Keystone RV Company

SAFETY ADVISORY # 16-251

Outback 326RL TV Bracket Screws

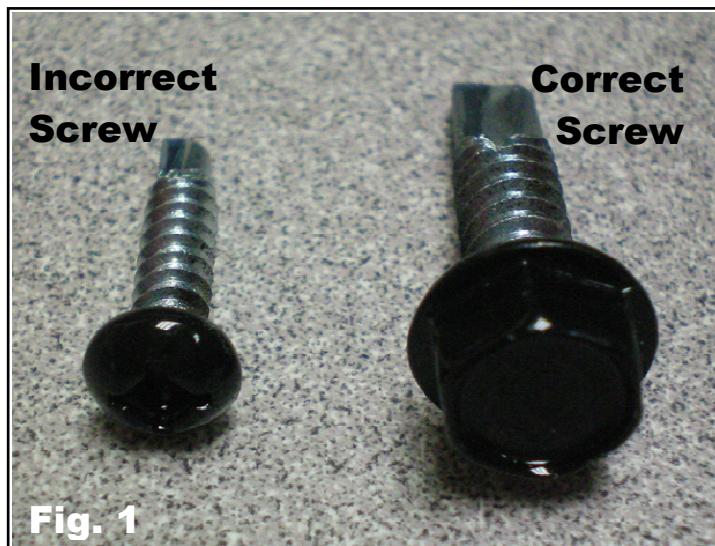
Keystone is conducting a voluntary **RECALL** notification campaign in accordance with the National Highway Transportation and Safety Act. It has been decided the vehicles in this recall population may have been manufactured with an interior TV bracket not properly secured to the wall. If the TV bracket breaks loose from the wall while a person is nearby, it will lead to an increased risk of personal injury.

Loosen the existing screws (#8 x 3/4" self-drilling) on the TV wall bracket. Keeping the parts together, remove the TV wall bracket and TV.

Parts Required per Unit: Purchase locally: (4) 1/4" - # 14 - 1" self-drilling screw

Remove TV wall bracket screws (#8 x 3/4" self-drilling). Using existing holes, re-install TV wall bracket and TV with 1/4" - #14 - 1" self-drilling screws, Fig. 1.
